## Product Change Notice (PCN)

PCN Number: **PCN-0450879R-01**

Product(s) Affected: **PJ1-021**

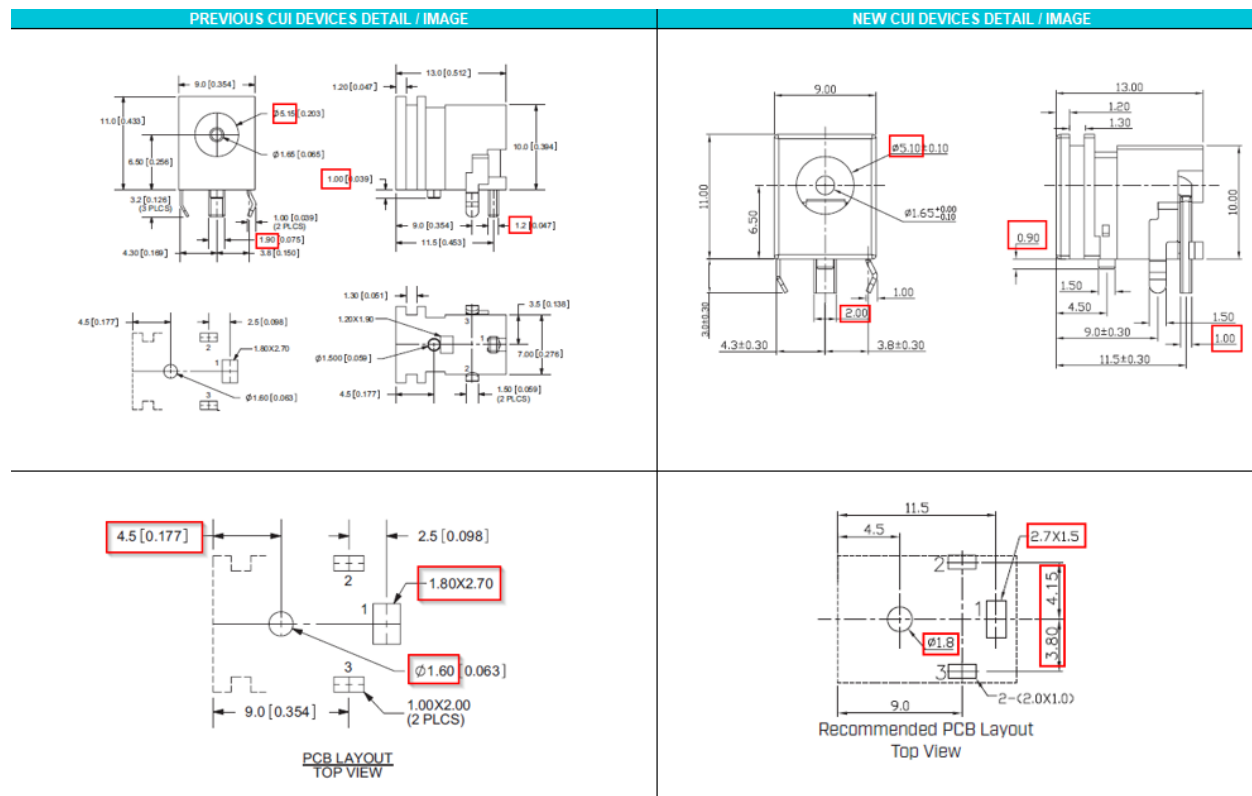
Description of Change: **Minor Housing and footprint differences. Material Change on the housing and terminals. See image Below**

PREVIOUS CUI DEVICES DETAIL / IMAGE			NEW CUI DEVICES DETAIL / IMAGE		
	MATERIAL	PLATING		DESCRIPTION	PLATING/COLOR
center pin	copper	silver		center pin	brass
terminal 1	copper	silver		terminal 1	brass
terminal 2	copper alloy	silver		terminal 2	bronze t=0.30
terminal 3	brass	silver		terminal 3	brass t=0.40
plastic	PBT			housing	PBT (UL94V-0)

<p>MATING PLUG Jack Insertion Depth: 8.5 mm</p>	 <p>MATING PLUG Jack Insertion Depth: 8.7 mm</p>
---	--
